## N9100A-02

# S E R V I C E N O T E

## N9100A 4080 series Parametric Test System

**Industrial PC requires SATA power conversion cable to replace**

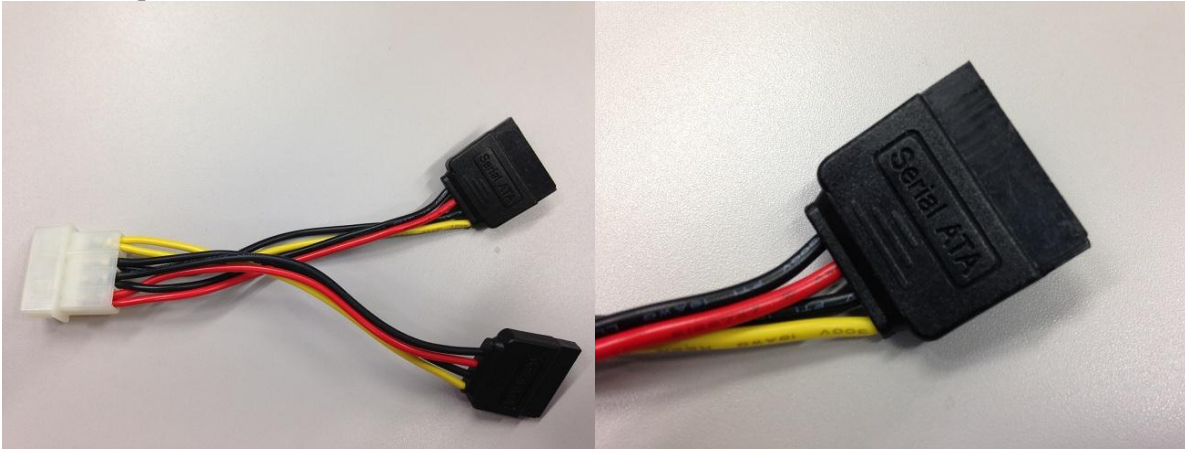
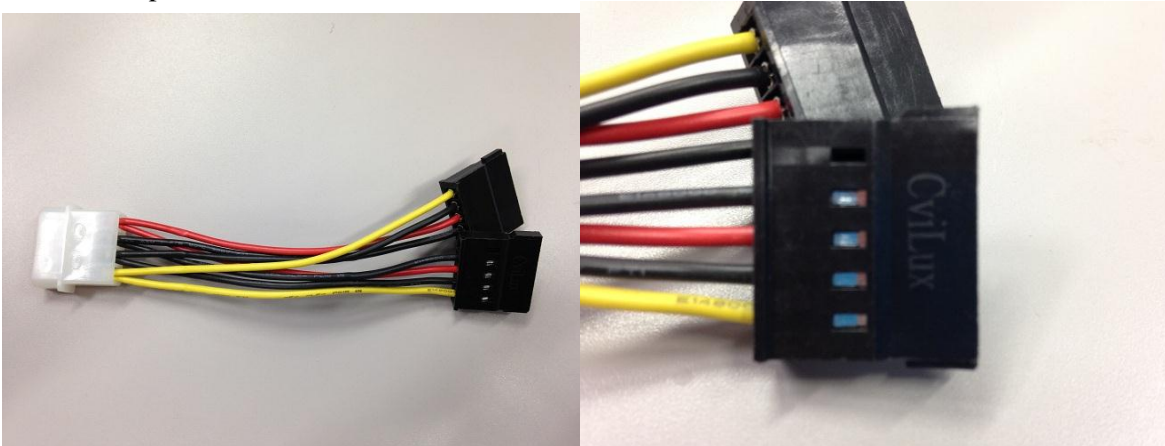
Agilent industrial PC includes SATA power supply conversion cable to connect power supply and HDD. Some IPC may have manufacturing issue at SATA power supply conversion cable, and it may have system fault by power fail.

PN 8121-2648 replacement SATA power supply conversion cable has SATA connector printed as “CvLux” instead old one has “Serial ATA”.

Replace SATA power supply conversion cable on Agilent industrial PC with new one (PN:8121-2648) .
